SERVICE BULLETIN RELEASE - 11/24/2014

09-045/14 - 2014-2015 MAZDA6 - REAR CONSOLE LID IS LOOSE

Subject: REAR CONSOLE LID IS LOOSE	Bulletin No: 09-045/14
	Last Issued: 11/24/2014

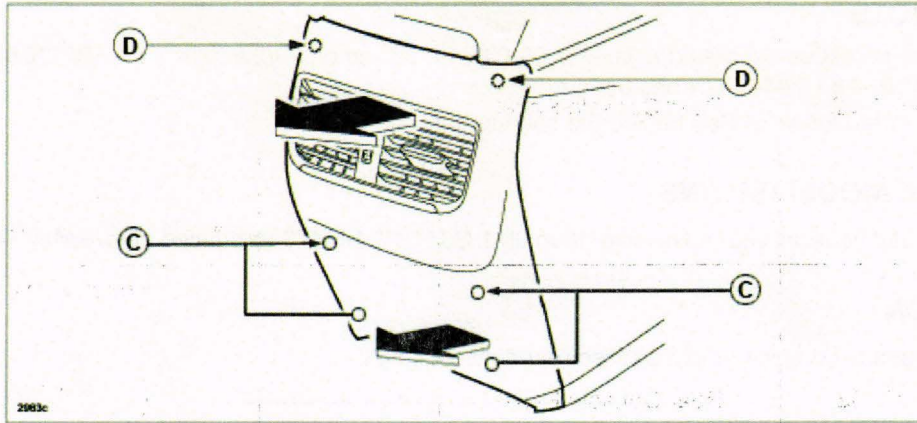
Some customers may complain about a loose rear console lid (A).

This may be caused by hinge pins coming partially off (B) or completely off.

4. Install a new rear console panel. (See PART(S) INFORMATION)

NOTE: The shape of the rear console panel has been changed, by adding a stopper rib to prevent the pin from coming off.
